DRAFT FINAL

**SEAD-25 and SEAD-26
PROJECT SCOPING PLAN FOR PERFORMING A
CERCLA REMEDIAL INVESTIGATION /
FEASIBILITY STUDY (RI / FS) AT THE FIRE
TRAINING AND DEMONSTRATION PAD (SEAD-25)
AND FIRE TRAINING PIT AND AREA (SEAD-26)**

REVISED DRAFT SEAD-25 AND SEAD-26
PROJECT SCOPING PLAN FOR PERFORMING
A CERCLA REMEDIAL INVESTIGATION/FEASIBILITY STUDY (RI/FS)
AT THE FIRE TRAINING AND DEMONSTRATION PAD (SEAD-25)
AND FIRE TRAINING PIT AND AREA (SEAD-26)

**PROJECT SCOPING PLAN
REMEDIAL INVESTIGATION/FEASIBILITY STUDY
AT SEAD-25 and SEAD-26
SENECA ARMY DEPOT ACTIVITY
ROMULUS, NEW YORK**

FIGURE 1-2
SITE PLAN

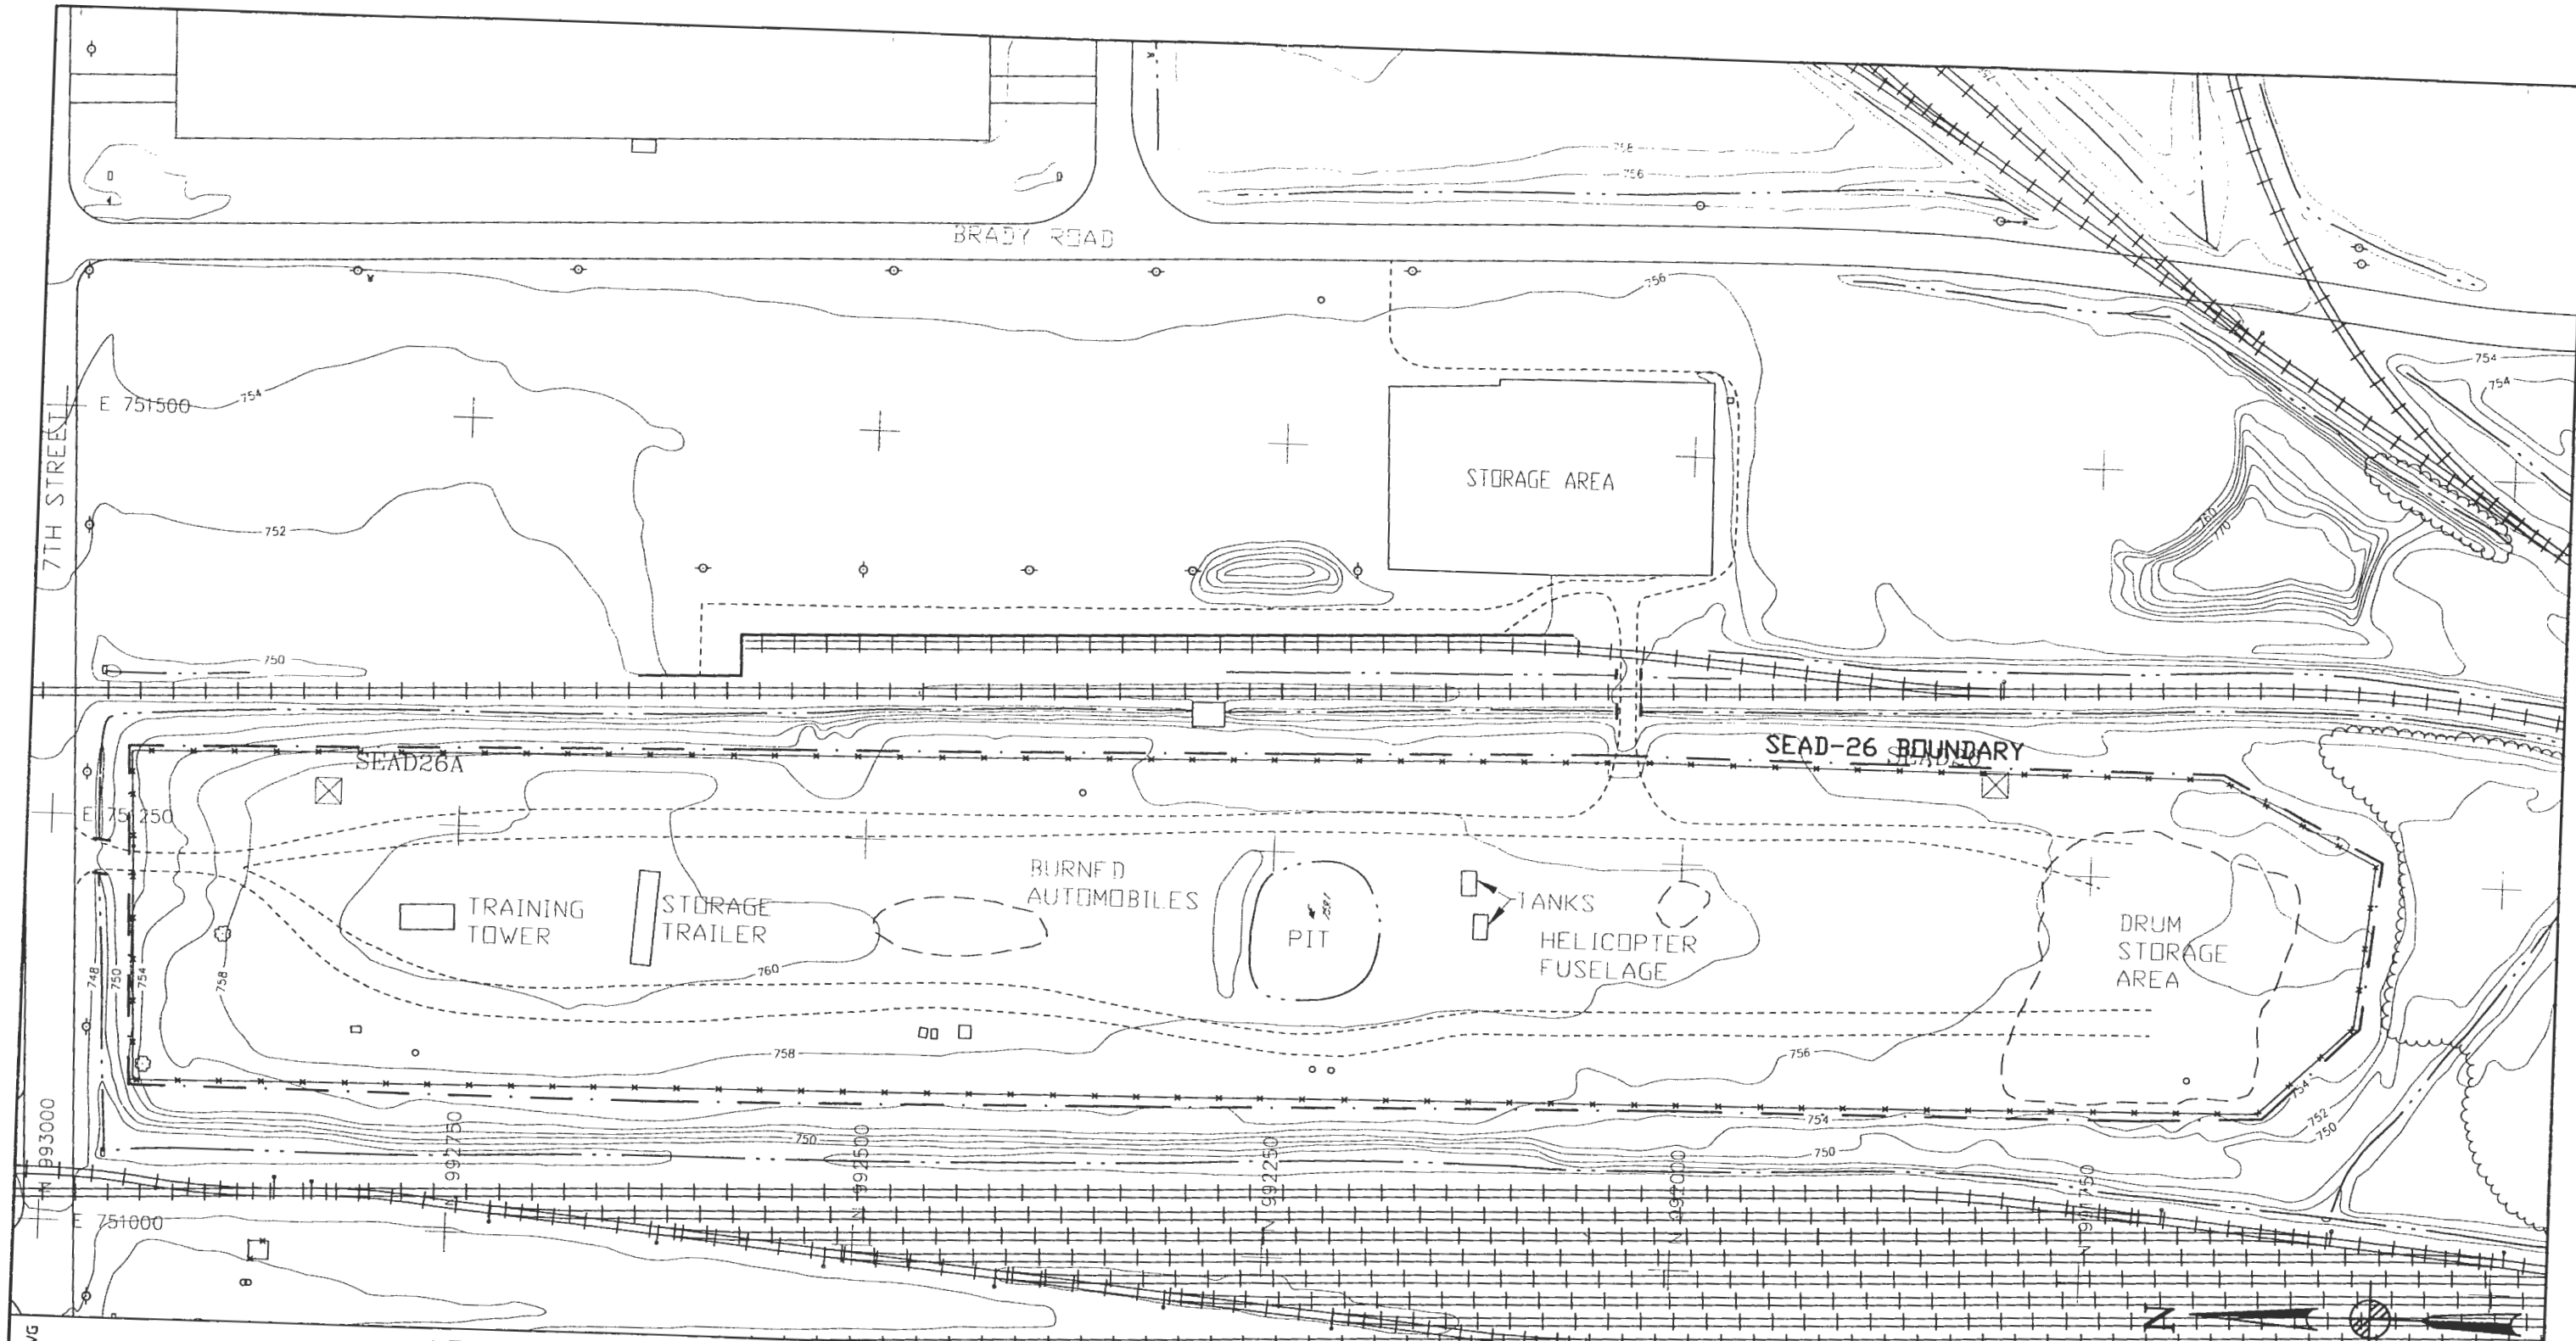
**Comment #1**           Page 1-3, Figure 1-2, Site Plan.

**Response #1**           Agreed. A legend listing the symbols used on the base maps for SEAD-25 and SEAD-26 will be included as Figure 1-4.

**FIGURE 2-2
 LOCATION OF ESI
 SAMPLING POINTS**

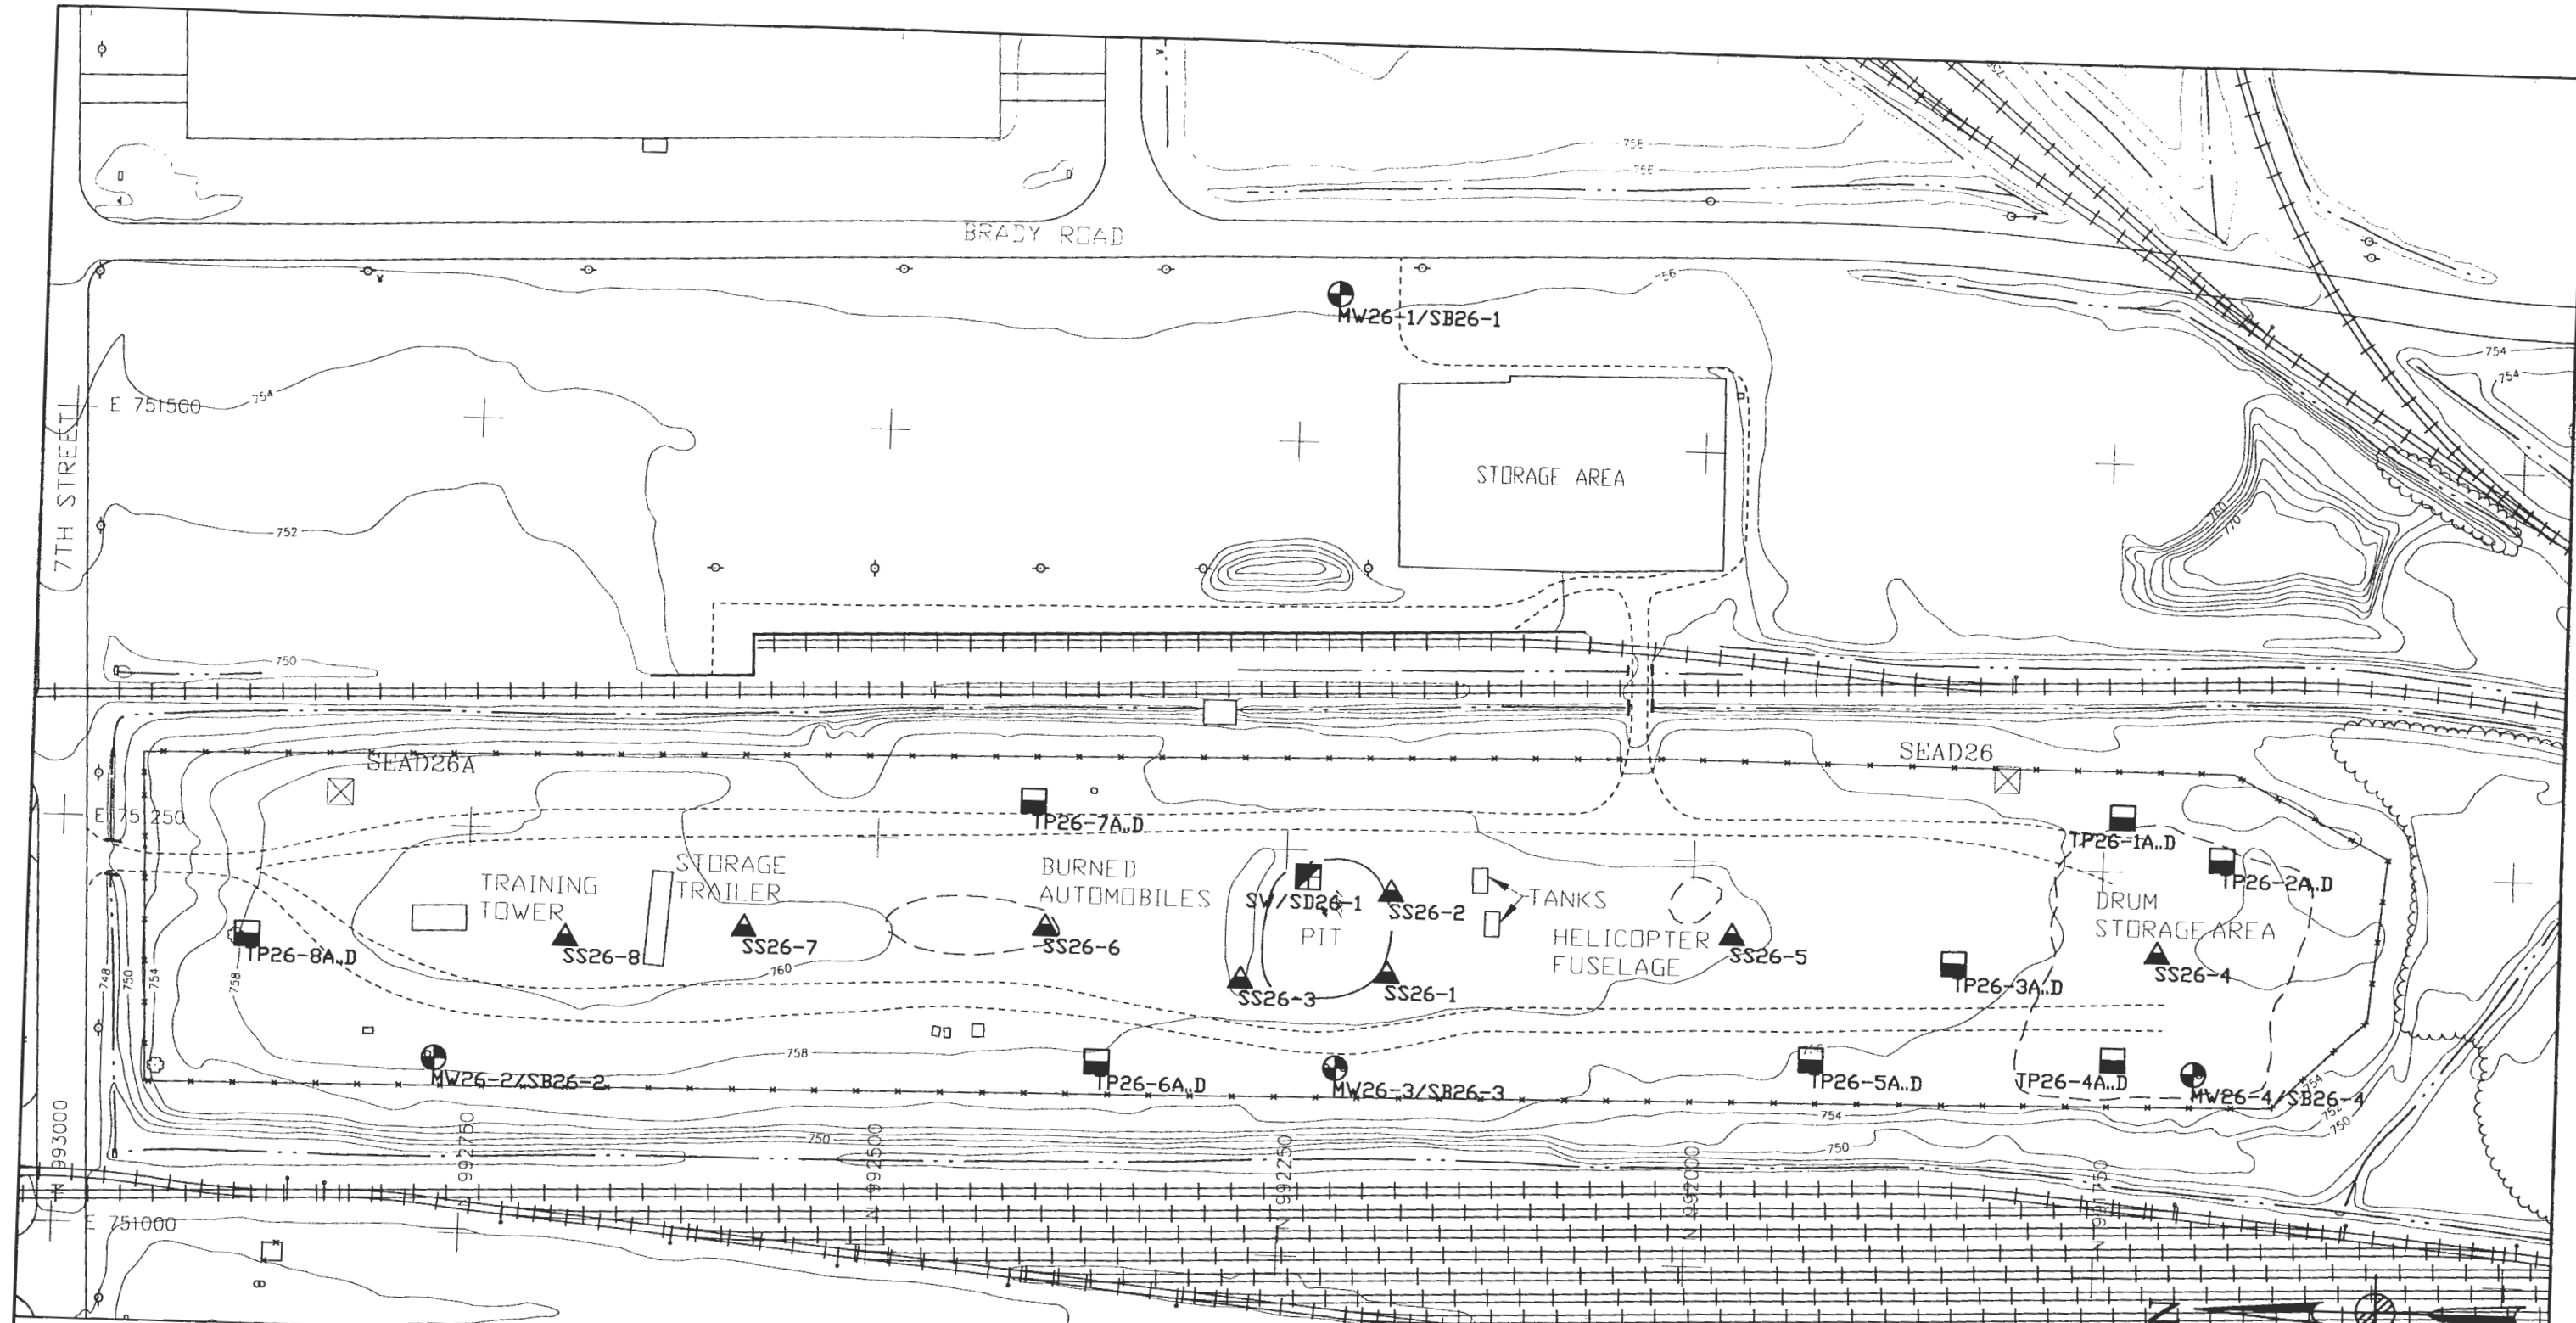
SB26-6 is not on Figure 2-2. Because this soil boring had the highest levels of SVOC contamination, its location is extremely important.

**Response #2**           Agreed. "SB26" is a typographical error that appears twice in that sentence. "SB26" was changed to "SB25". SB25-6 is the boring in which MW25-1 was placed. The well is labelled on Figure 2-2 as "MW25-1/SB25-6".

**FIGURE 3-2
 GROUNDWATER ELEVATION MAP**

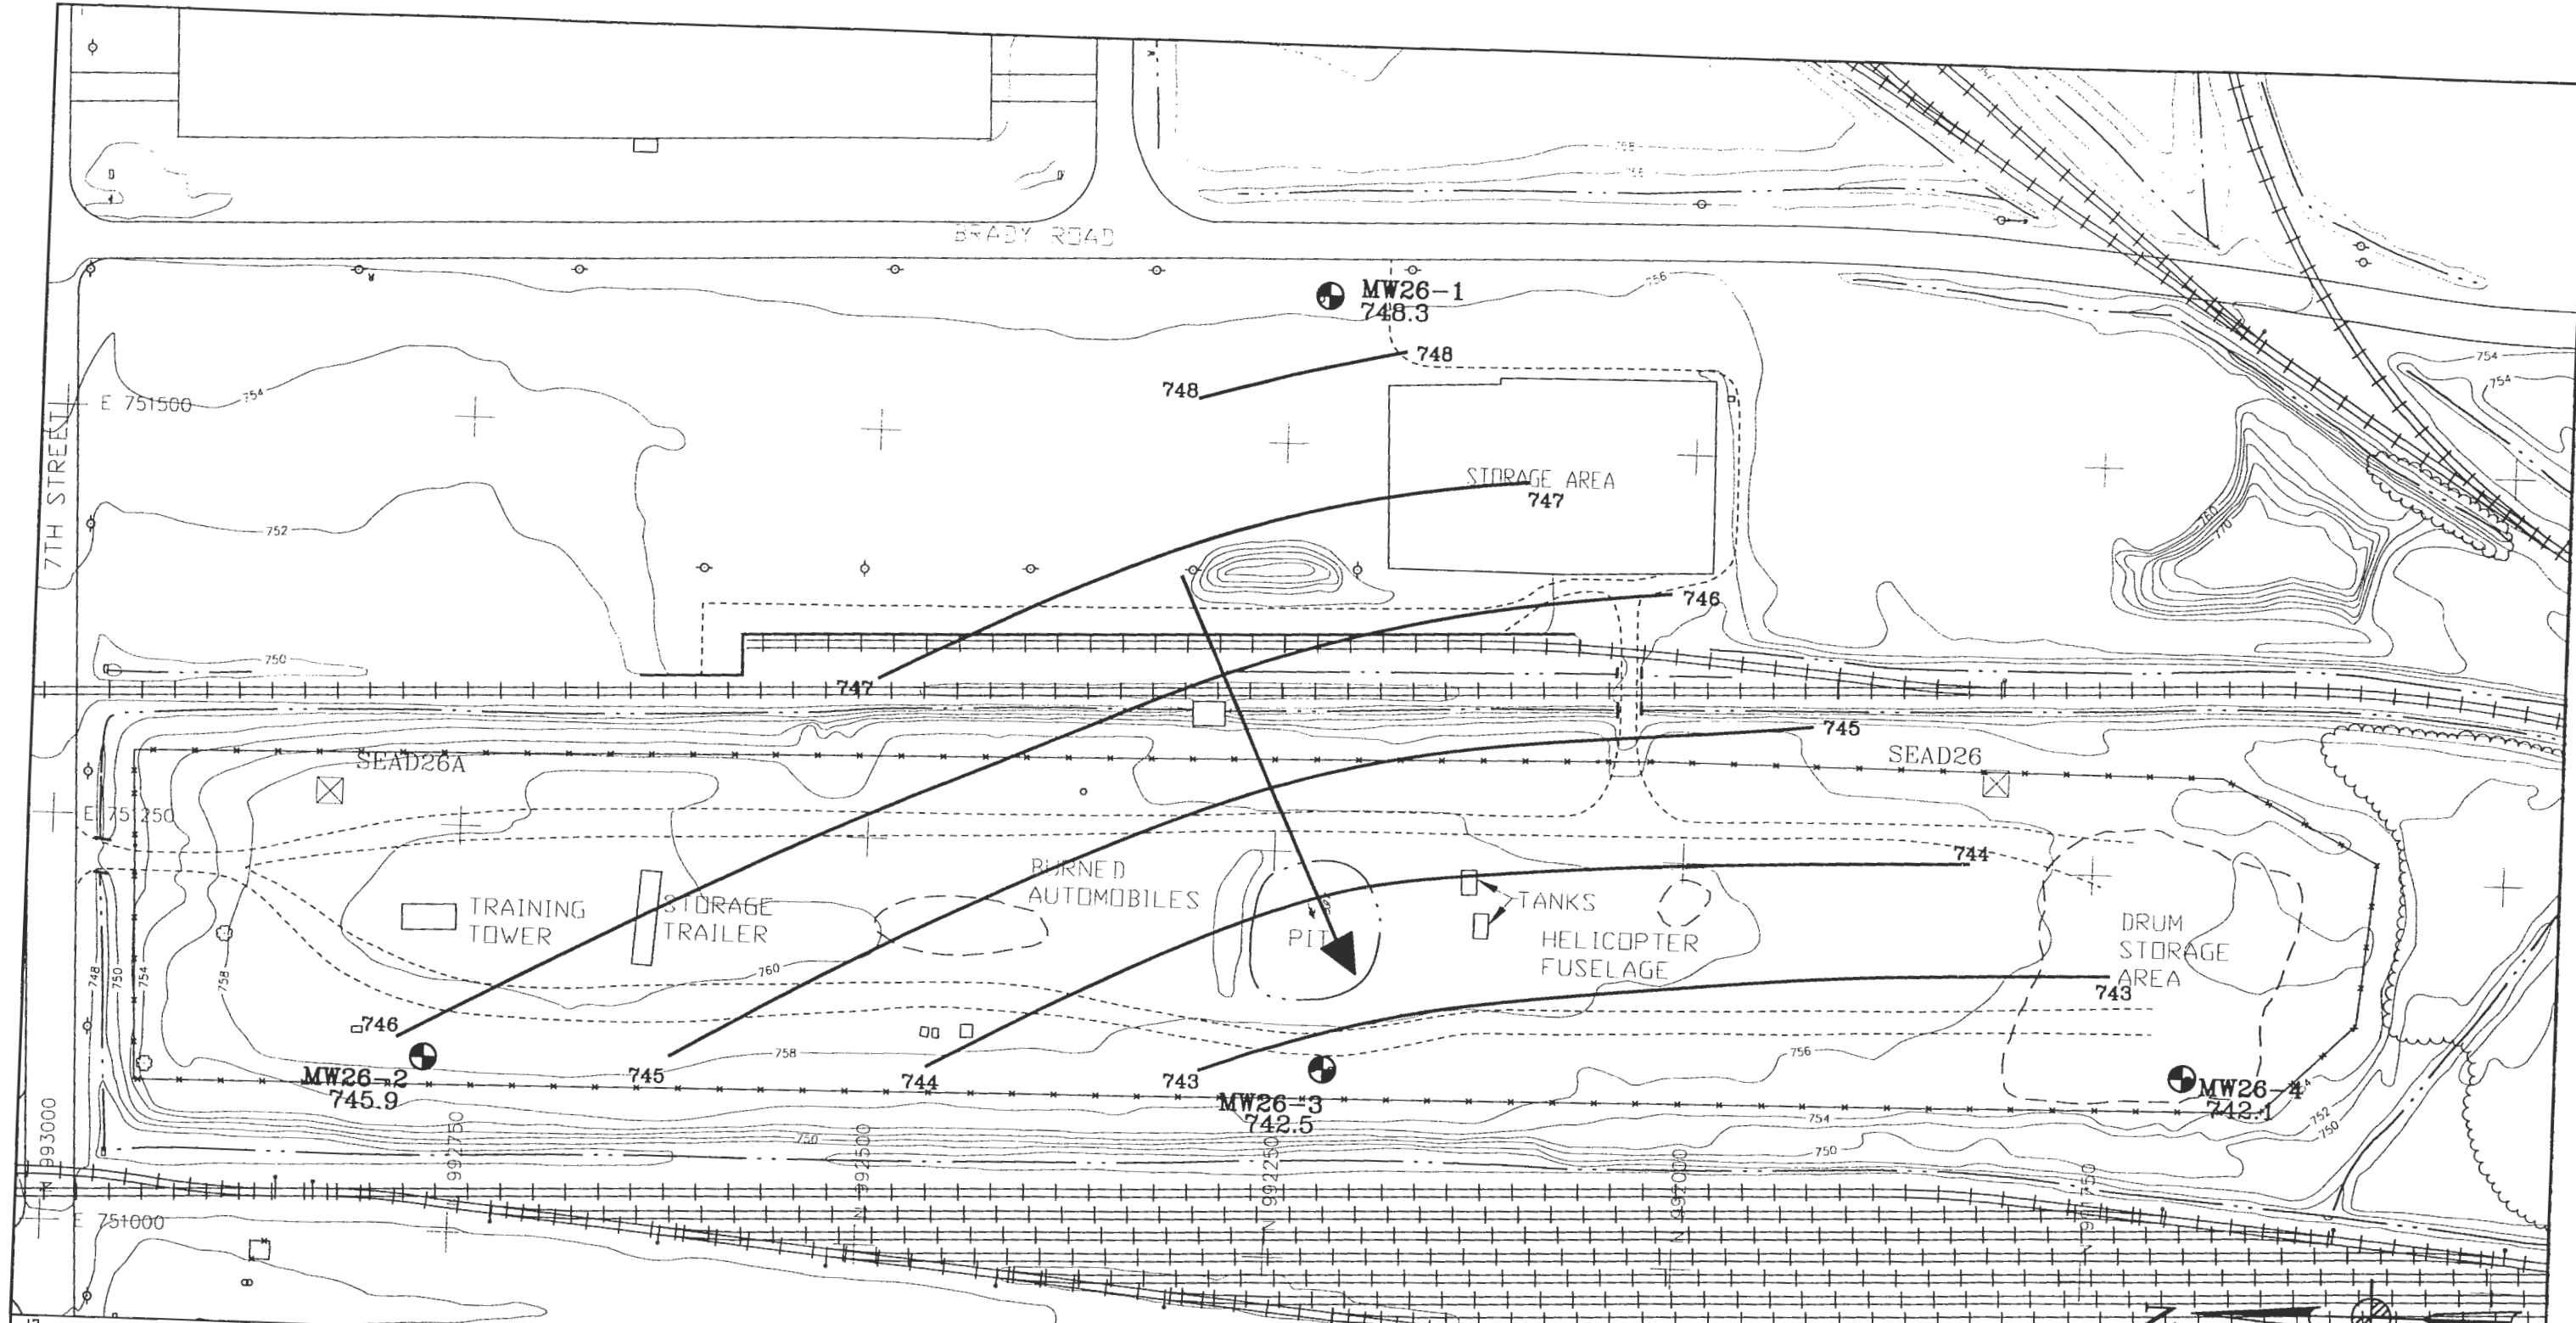
**Comment #5**                    **Figure 3-2:** The date of the water level data collection shown on this figure does not correspond with any of the dates shown in Table 3-2.
